Re: Port Ewen Fire District

Port Ewen Firehouse Construction Project

Addendum #3

DATE: 8/30/2023
DRAWN BY: AMRDA
SCALE: AS SHOWN
REVIEWED BY:
PROJECT NO.: 21-2343
FILE: E-020 ELECTRICAL SITE PLAN

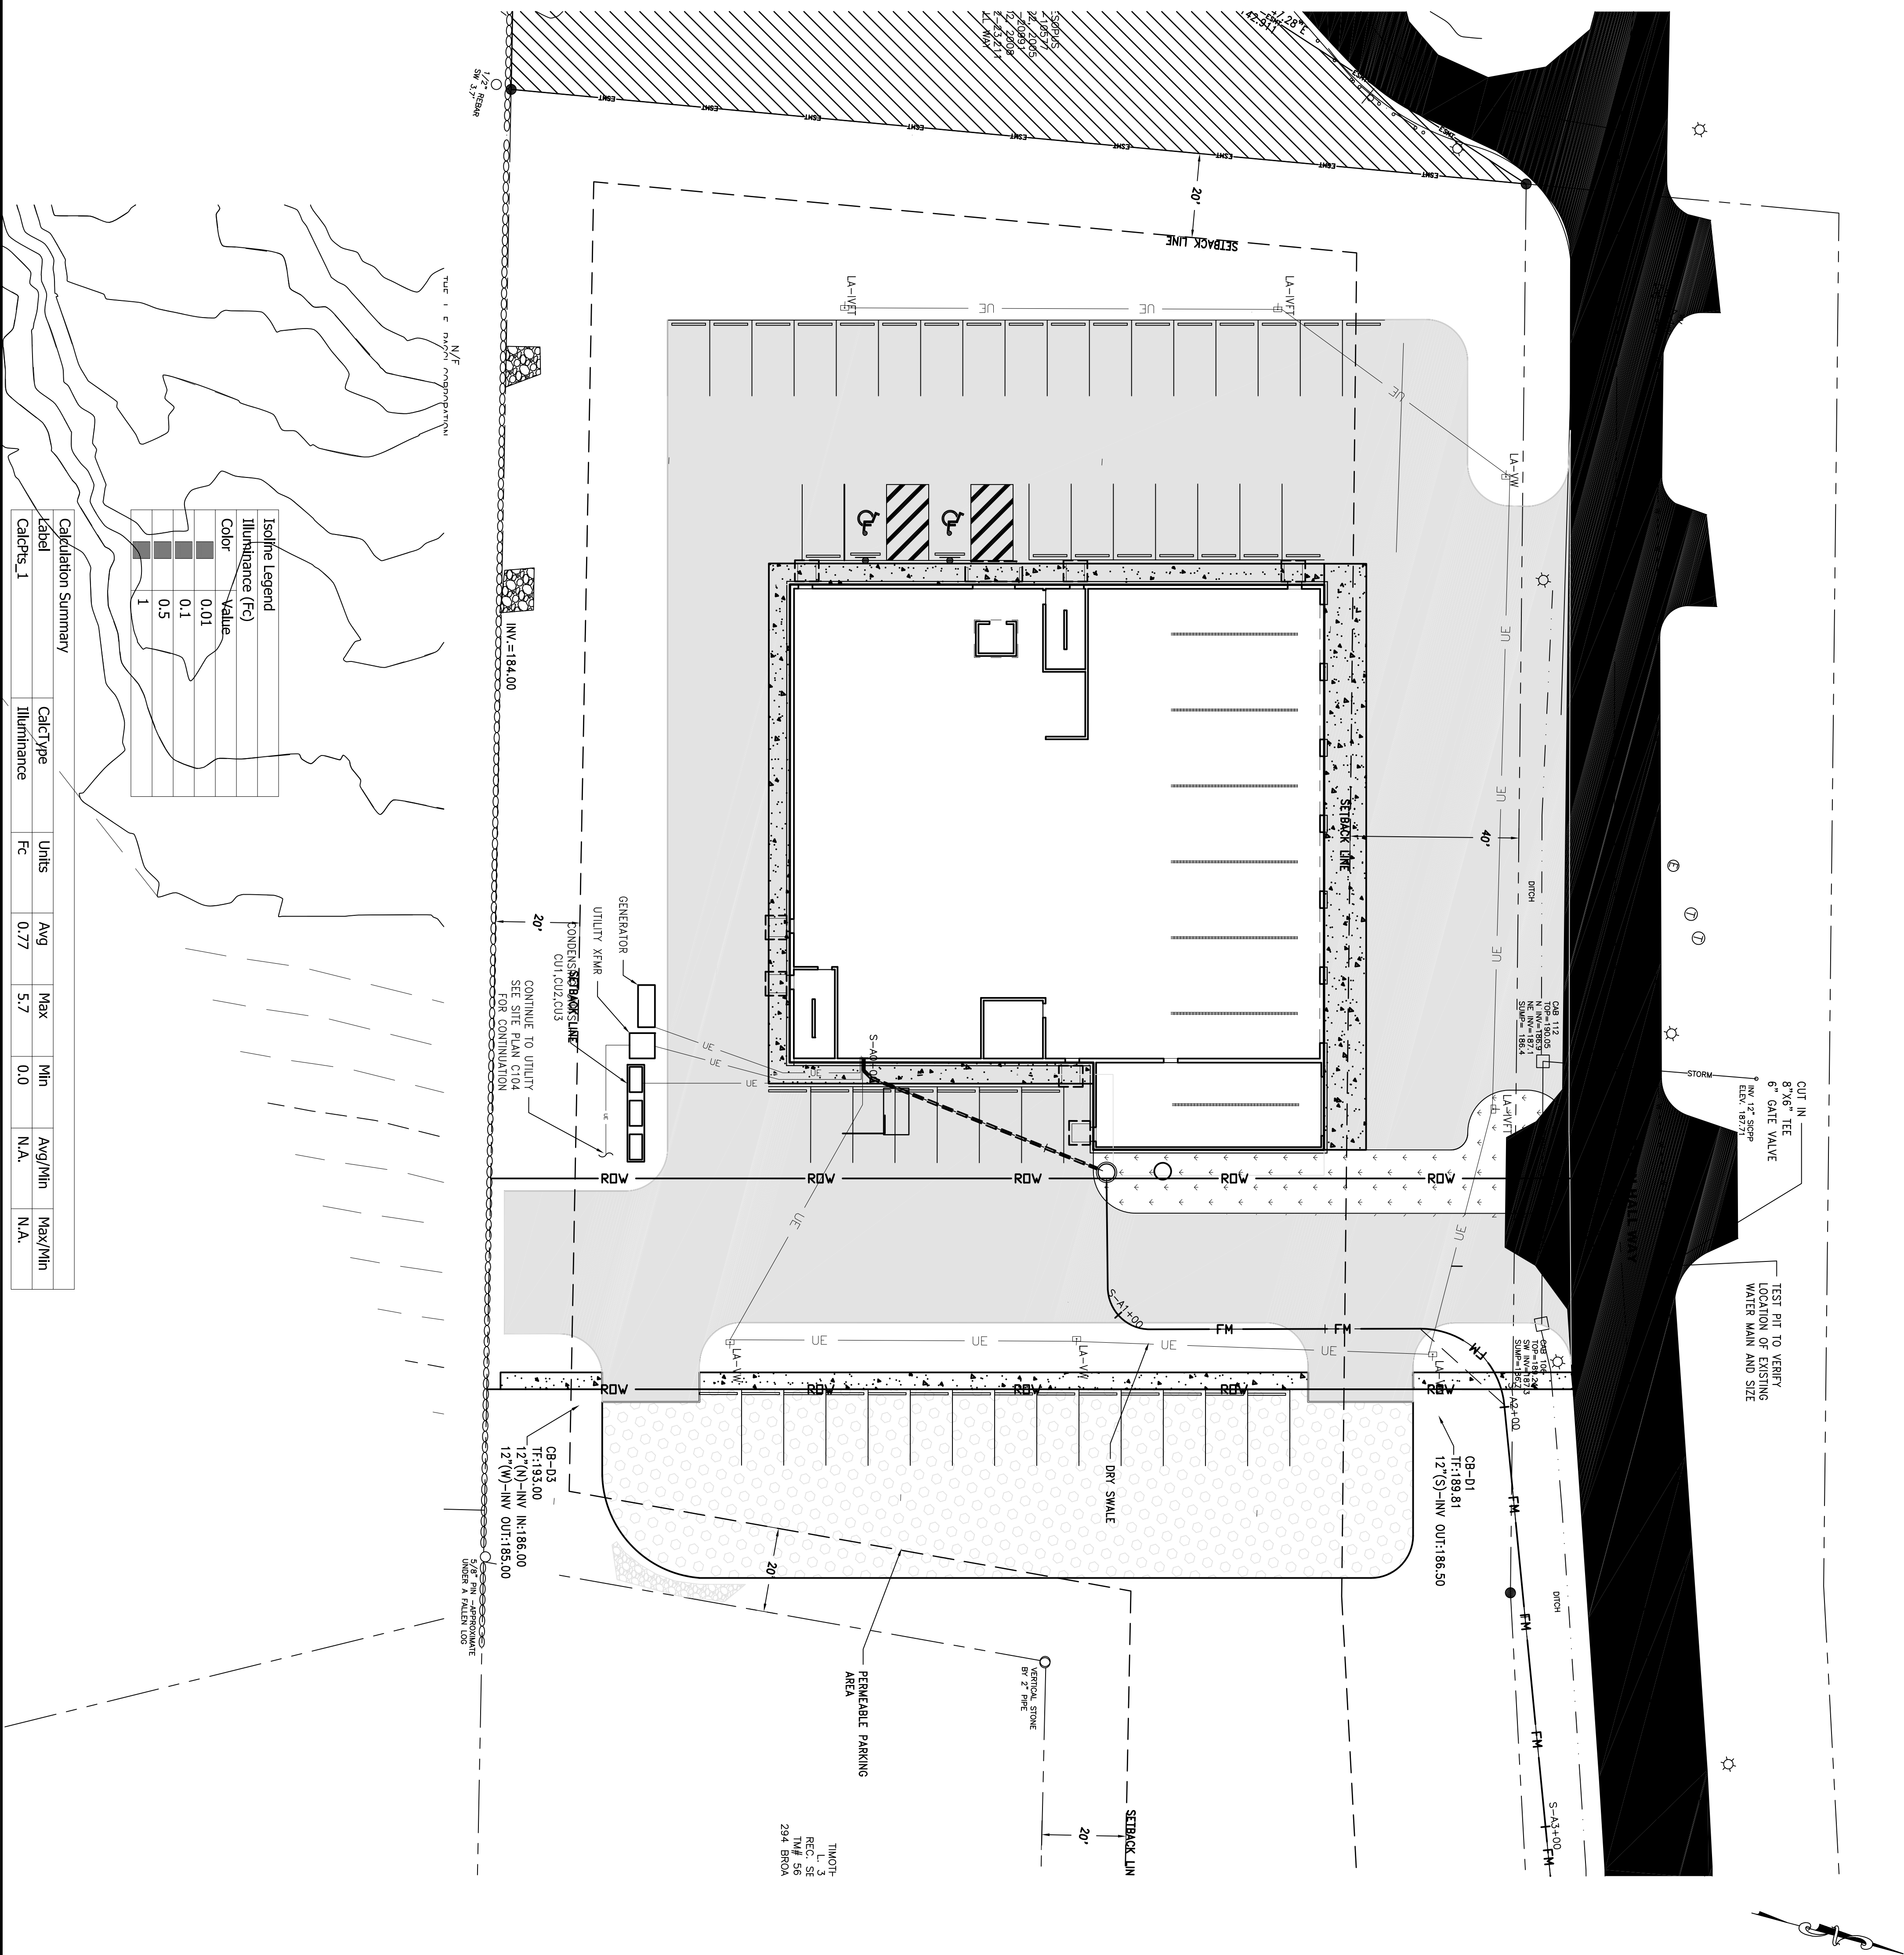
- Relocated one LA-IVFT fixture to the firehouse side of Town Hall Way.
- See attached plan with revisions.

SHEET:
E-201

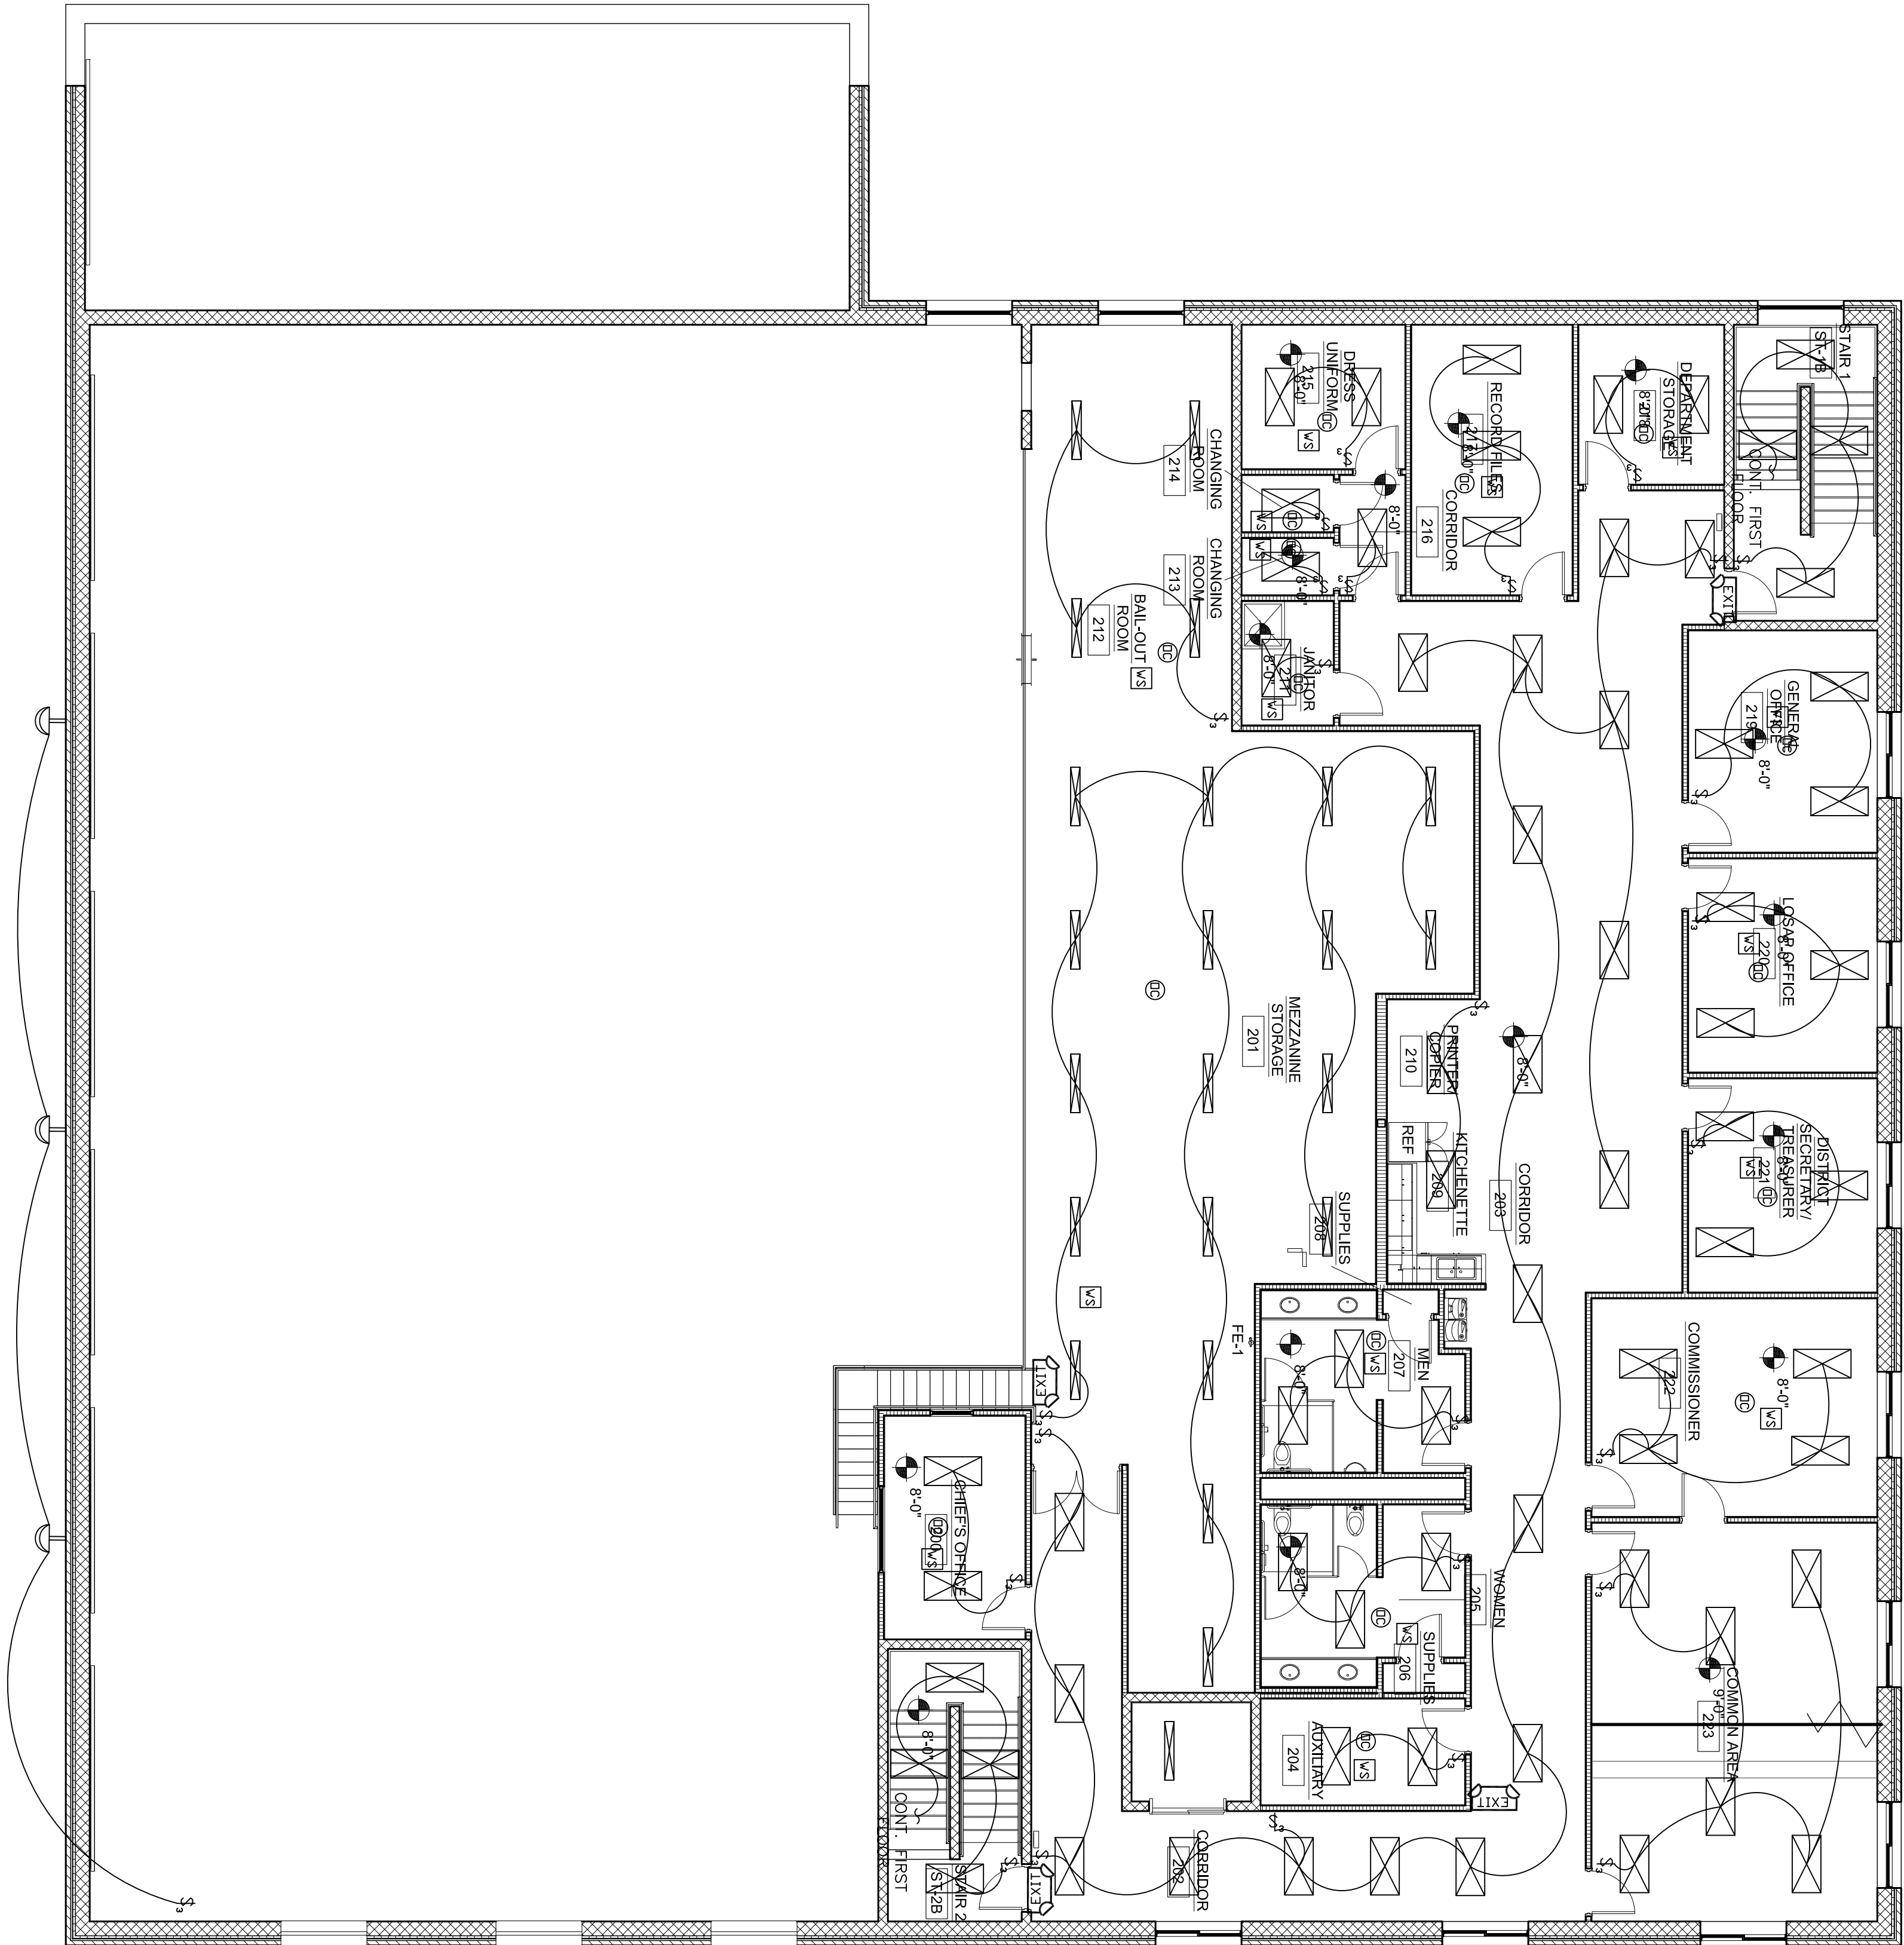
- Added emergency exit lights to the floor plan.
- See attached plan with revisions.
